**ITEM****48-50 Wellington Road, Chester Hill**

**Construction of a 5-storey residential flat building including 37 affordable housing units with basement car parking.**

**FILE****DA-861/2020****PPSSSH – 33****ZONING****R4 High Density Residential****DATE OF LODGEMENT****28 September 2020****APPLICANT****Land And Housing Corporation****OWNERS****Land And Housing Corporation****ESTIMATED VALUE****\$17,470,376****AUTHOR****Casandra Gibbons****SUMMARY REPORT**

# **DA-861/2020 ASSESSMENT REPORT**

**Figure 4:** DCP Map Excerpt – site located by with blue arrow added

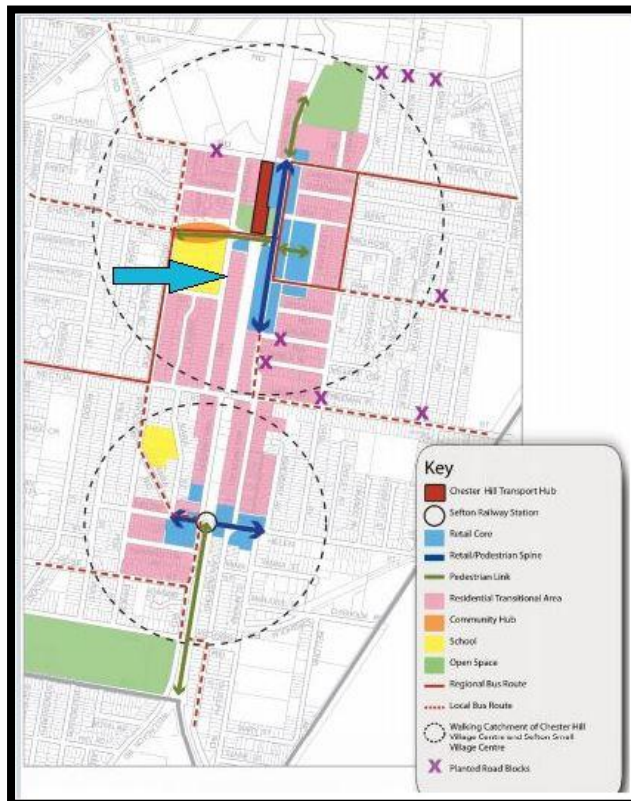
The subject site is shown as being located within the residential area of transition. The development is consistent in achieving the objectives of the control as it provides for a redevelopment and increase in housing stock. Section A1 contains controls for development, typically applying to only the business zone, however clause 2.5 of Section 4 of Part A1 applies to this site and has been assessed below.
